Office Action Summary

10/631,111

CHEN ET AL

DETAILED ACTION

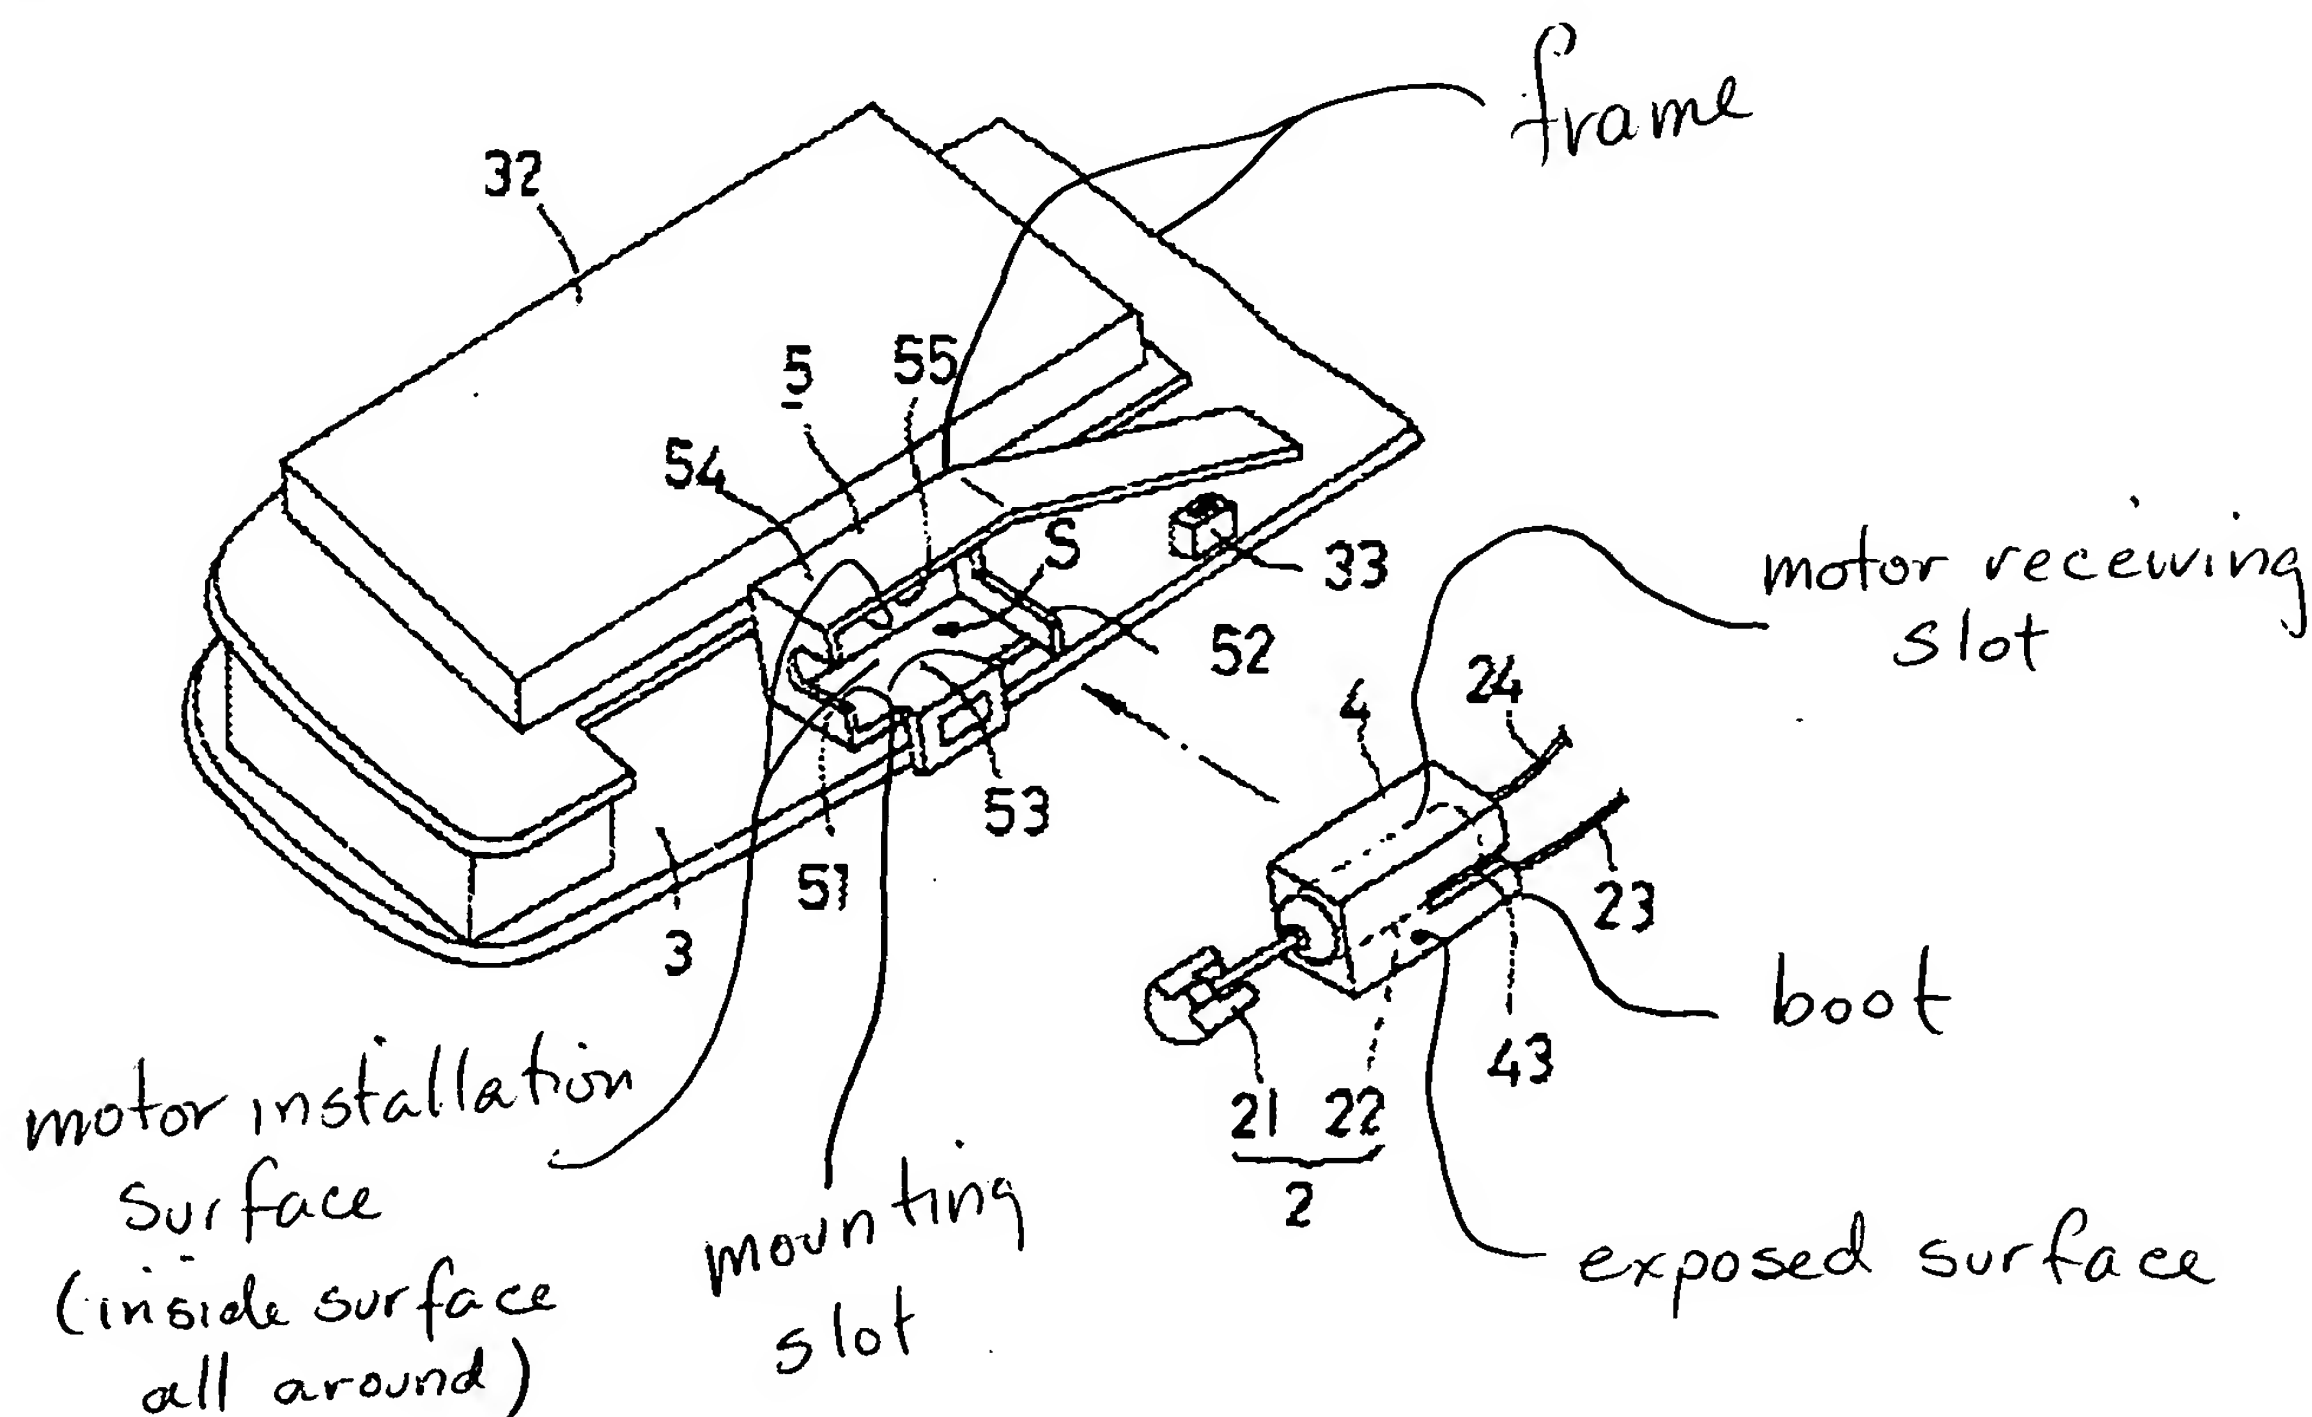
Claims 4 and 5 are rejected under 35 U.S.C. 102(b) as being anticipated by Miyake (6,714,123). Miyake teaches each feature of the claimed invention as shown below.
